Tender No. : <u>01/CS/2014</u>

Name of work: Supply, Installation, Commissioning, Facility Construction & Maintenance of

Drive-through Container Scanner (Road)

Subject : Clarifications to site related queries/issues raised in pre-bid meeting – ICTT,

SCANNER BORE HOLE DRAWING:

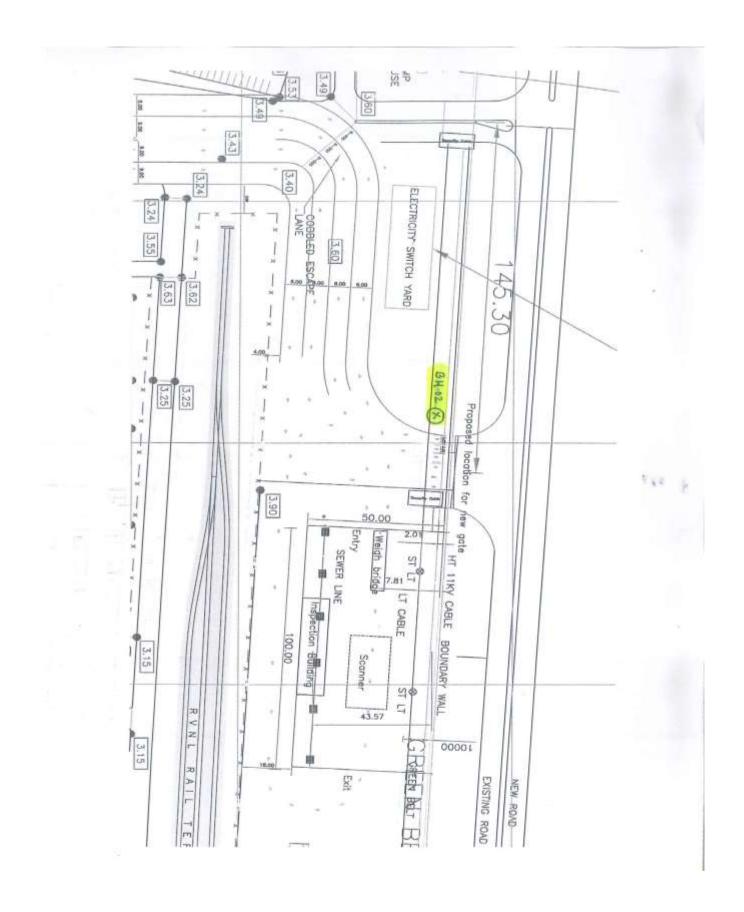
4	C	(111((
4	Geo-	technical investigation	D 1 1 1 2 1 1 2 2 1 1 2 2 1 1 2 2 1 1 2 2 1 1 2 2 1 1 2
		Are there any geo-technical report pertaining to the site for scanner installation available?	Bore-hole location and data as available with CoPT is attached. However, Bidder is advised to carry out geo-technical investigation of the scanner plot in order to obtain the details of underground strata and to decide on founding level and foundation design.
5	Foun	dation
